## **URBAN DESIGN specialist report**

**Date:** 13 October 2015

**Subject:** **URBAN DESIGN REPORT**

## **PLAN CHANGE 79, REZONNING OF QUEEN ELIZABETH SQUARE**

**Figure 1** Downtown West desired future outcomes including laneways<sup>1</sup>.

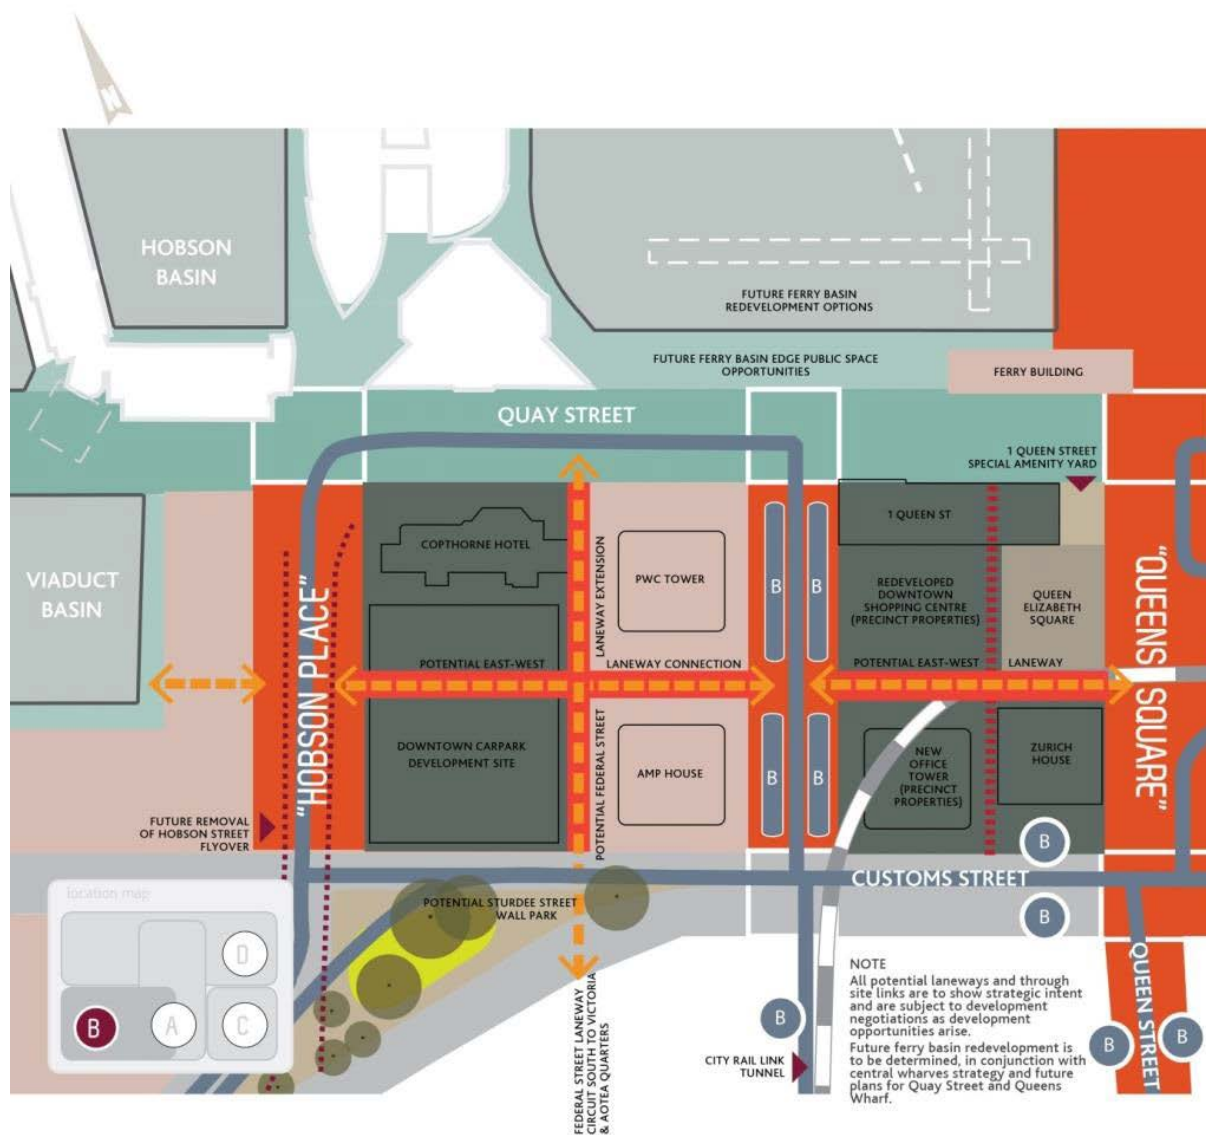
- 3.8 The public space, movement network and development potential are set out in **Figure 1**. One of the important proposals is the bus relocation from Lower Queens Street to Lower Albert Street to free up space for pedestrian and event capability in the Lower Queen Street area. The laneway connection through the Downtown site will provide significant functional pedestrian

connections between public transport facilities in a east-west and north-south direction for the transport interchange functions of the area.

- 8.8 Within the *Downtown Framework* document endorsed by the 11 September 2014 Auckland Development Committee, one of the important proposals was the bus relocation from Lower Queen Street to Lower Albert Street. For this to work there needs to be laneway connections between public transport

facilities both in an east-west and north-south direction as envisioned in Figure 1.

8.9 In my opinion specific requirements (as detailed in my Topic 050 Downtown West Precinct Evidence for the PAUP) are needed to create vibrant public laneways that support the transport interchange functions and these are:

- a) Open and accessible to the general public 24 hours/day and 7 days a week without doors, gates or wind lobbies.
- b) At grade and provide the shortest straight route between street and have straight lines of sight.
- c) A minimum pedestrian width of 5 metres clear for unimpeded flow of public transport users between streets.
